Item ID: D205-634-041 **Accept** *N900040100* **Setup Start** *NS1*

Item Name: Replacement Skidtube

DRAWING NO.	TITLE	REV.	DART AEROSPACE LTD	D.E.O. NO.	SHEET NO.	SCALE
D2580	205 SKIDTUBE ASSEMBLY	E	ENGINEERING ORDER	D2580-E-1	SHEET 1 OF 1	NTS

PURPOSE:
CHANGE ALL C'BORED WELDED CROSSBOLT SPACERS TO SWAGED SPACERS

SECTION B-B, F-F, I-I
NOT TO SCALE

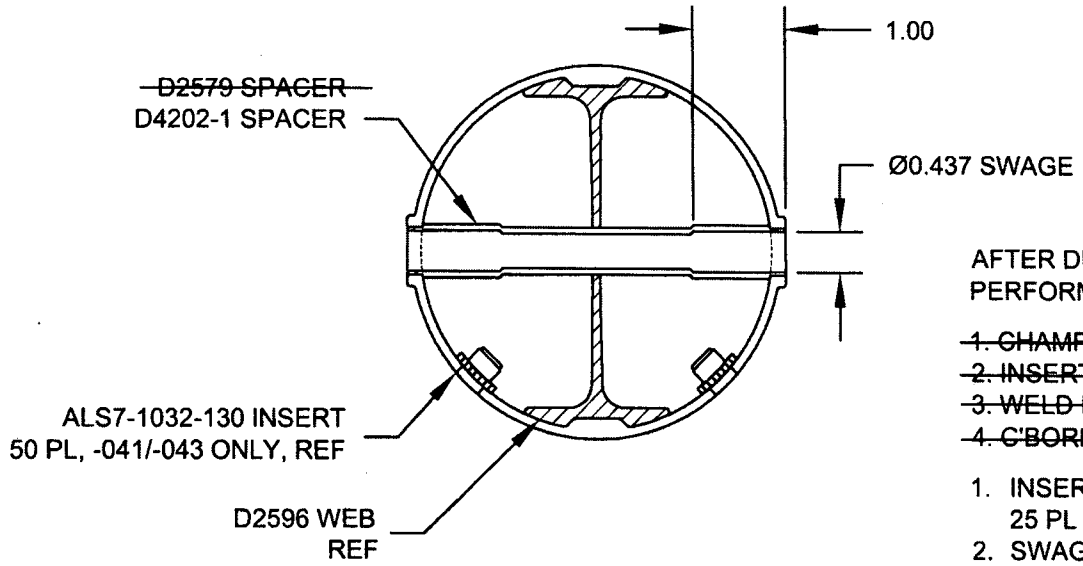
SECTION B-B, SECTION F-F, & SECTION I-I ARE AMENDED AS FOLLOWS
FOR ALL HOLES THAT WERE ORIGINALLY C'BORED:

4		* D2579	CROSS BOLT SPACER
20	20	25	D4202-1	SPACER

*** FOR -045 SKIDTUBE ONLY:**
WELD 4X D2579 SPACERS PER DWG
IN LOCATIONS MARKED "**NO C'BORE**".
REF SHEET 4 OF DWG.
